**From:** Michael Fitts <gostodas1@yahoo.com>  
**Sent:** Thursday, February 21, 2013 10:59 AM  
**To:** Bradford, Darren@Waterboards  
**Subject:** Comments re Tentative Order No. R9-2013-0007; Place ID: 785677  
**Attachments:** Tesoro\_letter\_plus\_figures\_out.pdf

**Subject:** Review of TCA's Report of Waste Discharge Application for the Tesoro Extension Project

Tesoro Extension Project WDR Review  
**Figure 1**  
Lane's Balance

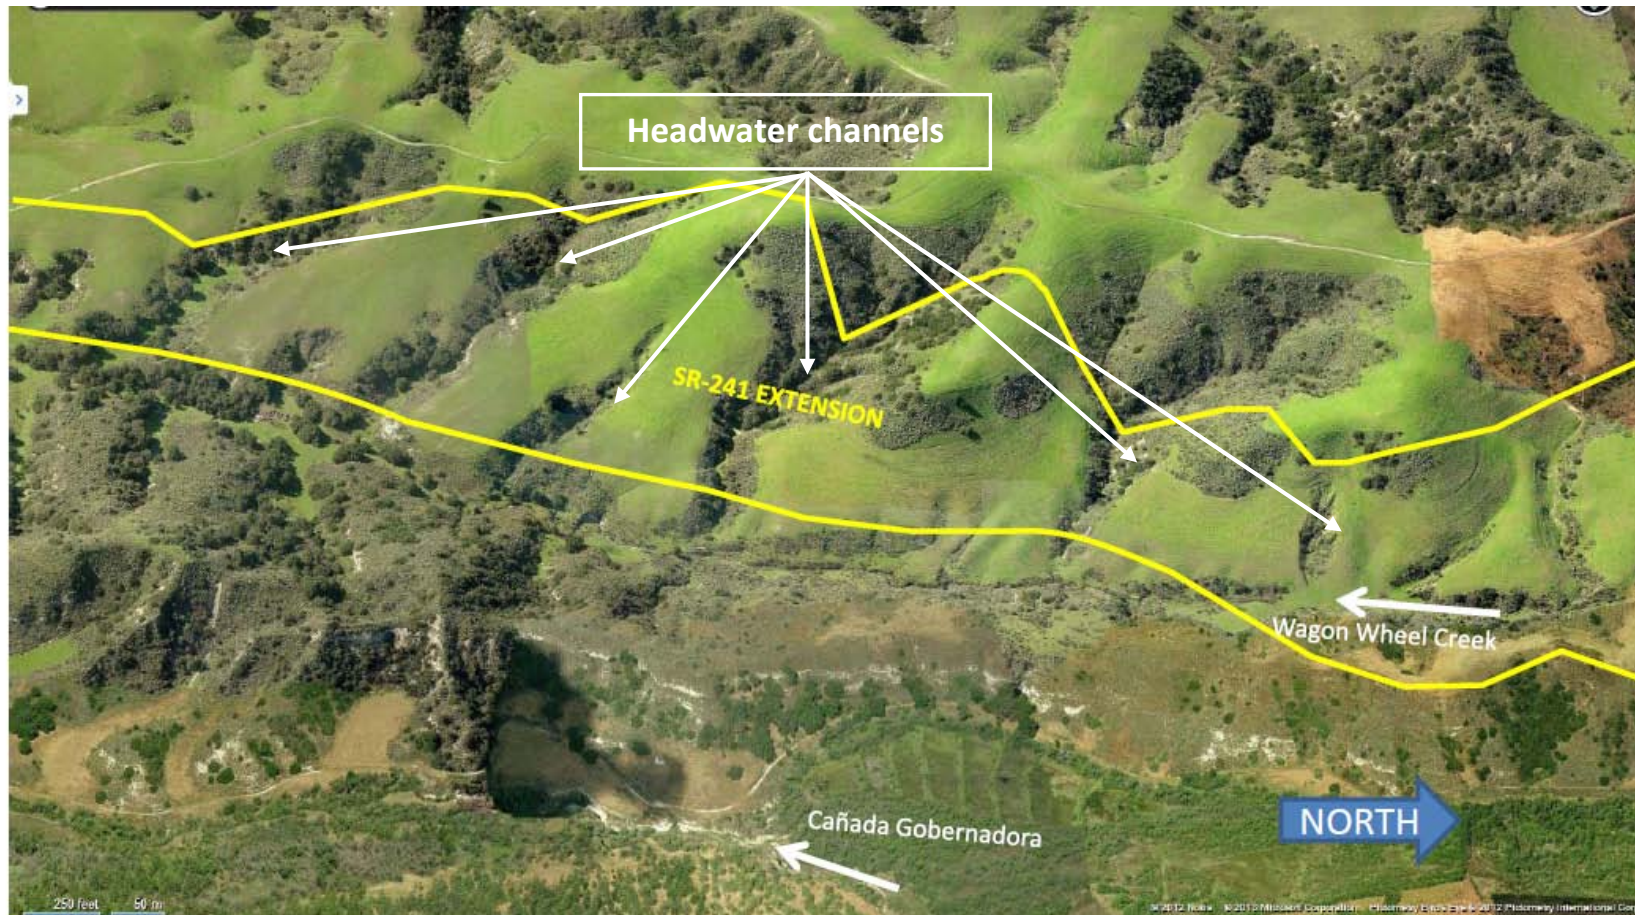
To illustrate the interaction between sediment, discharge, and channel response, a qualitative expression was presented by Lane (1955) describing a balance between sediment supply, sediment size and the erosive power of stream discharge. This expression is shown below:

This relationship shows that the mass of sediment<sup>1</sup> transported by a stream is proportional to the discharge and slope, with changes in the balance to the water or sediment supply resulting in channel adjustments through either erosion (degradation) or deposition (aggradation). It is helpful to display this graphically in what is known as Lane's Balance, shown in Figure 1. As illustrated in Figure 1, an increase in water discharge ( $Q_w$ ) or a reduction in coarse sediment load can both lead to channel erosion. To prevent damaging changes to stream channels, both runoff and sediment supply must be kept in balance. While older stormwater regulations have focused on preserving pre-project runoff, more recent regulations including the Orange County HMP have

According to sediment transport principals as illustrated graphically by Lane's balance, reduced bedload supply to these channels would result in channel degradation consistent with observations of channel response due to hydromodification. These effects would be channel incision, headcut migration, bank failure and loss of aquatic habitat, all of which would negatively affect beneficial uses of downstream channels.
